Sundry Print Report

Well Name: MALJAMAR SWD 29 Well Location: T17S / R32E / SEC 29 / County or Parish/State: LEA /

Notice of Intent

Procedure Description: This is a revision to the Sundry ID: 2646726 that was approved on 01/10/2022. Please find revised procedure and WBD attached for your use. Thank you.

Maljamar SWD 29 #1

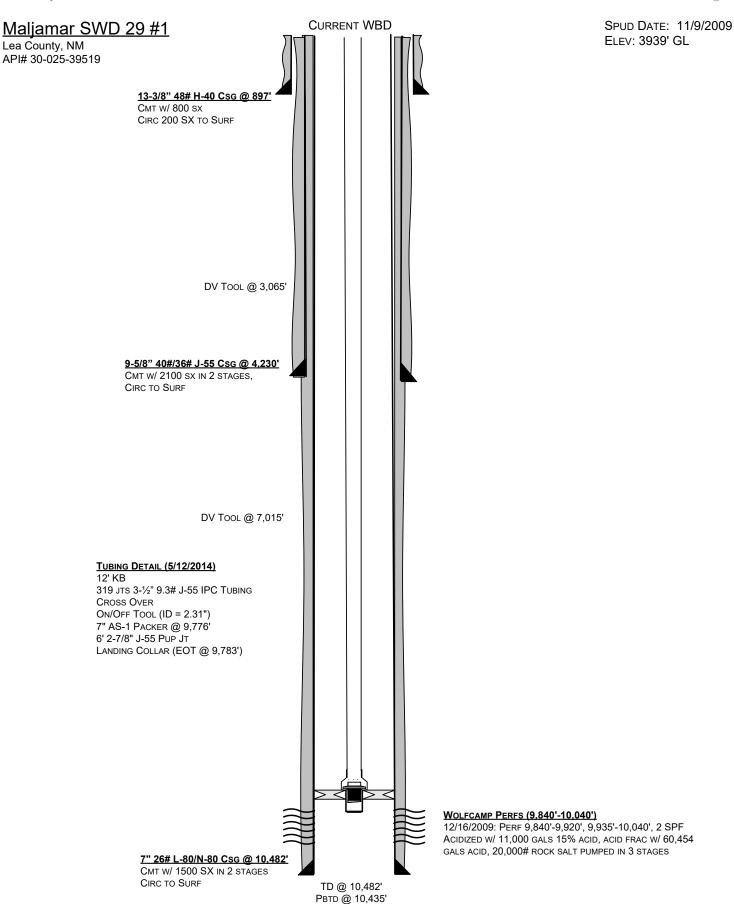
- 1. Notify BLM and OCD 24 hrs before rigging up
- 2. MIRU Pulling unit
- 3. Blow well down to 0
- 4. ND WH and NU Hydraulic BOP
- 5. Spot LD machine and work string

- 6. MI and RU snubbing unit
- 7. PU RBP retrieval tool and retrieve first RBP at 6,950'
- 8. POOH and LD RB
- 9. RIH and retrieve second RBP at 9,774'
- 10. Send both RBPs in to be inspected

- 11. MI tested RBP and set at 2,500'
- 12. Blow down well pressure and perform a negative pressure test for 30 mins
- 13. Pressure up on well to 500 psi and pressure test for 30 mins

- 14. If both pressure tests are successful, unset the RBP and move it to 9,740' and set RBP
- 15. Blow down well pressure and perform a negative pressure test for 30 mins

- 16. Pressure up on well to 500 psi and pressure test for 30 mins
- 17. If both pressure tests are successful at 9,740, unset RBP and POOH while LD WS
- 18. MI polycore injection tubing, injection packer and BHA

- 19. RIH while snubbing and hydrotesting
- 20. Set packer at 9,776' and get off on/off tool
- 21. Circulate packer fluid
- 22. Latch back onto packer and test to 500 psi

- 23. ND Snubbing unit and BOP, NU wellhead
- 24. Notify OCD/BLM 24 hrs before performing MIT
- 25. Conduct MIT test before resuming injection

Maljamar SWD 29 #1

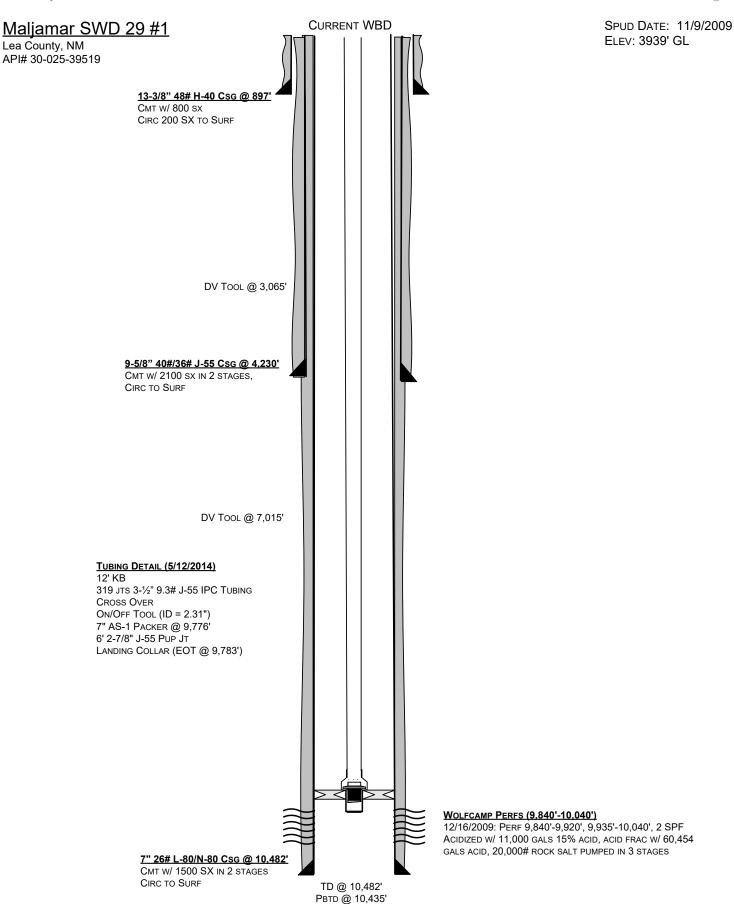
- 1. Notify BLM and OCD 24 hrs before rigging up
- 2. MIRU Pulling unit
- 3. Blow well down to 0
- 4. ND WH and NU Hydraulic BOP
- 5. Spot LD machine and work string

- 6. MI and RU snubbing unit
- 7. PU RBP retrieval tool and retrieve first RBP at 6,950'
- 8. POOH and LD RB
- 9. RIH and retrieve second RBP at 9,774'
- 10. Send both RBPs in to be inspected

- 11. MI tested RBP and set at 2,500'
- 12. Blow down well pressure and perform a negative pressure test for 30 mins
- 13. Pressure up on well to 500 psi and pressure test for 30 mins

- 14. If both pressure tests are successful, unset the RBP and move it to 9,740' and set RBP
- 15. Blow down well pressure and perform a negative pressure test for 30 mins

- 16. Pressure up on well to 500 psi and pressure test for 30 mins
- 17. If both pressure tests are successful at 9,740, unset RBP and POOH while LD WS
- 18. MI polycore injection tubing, injection packer and BHA

- 19. RIH while snubbing and hydrotesting
- 20. Set packer at 9,776' and get off on/off tool
- 21. Circulate packer fluid
- 22. Latch back onto packer and test to 500 psi

- 23. ND Snubbing unit and BOP, NU wellhead
- 24. Notify OCD/BLM 24 hrs before performing MIT
- 25. Conduct MIT test before resuming injection
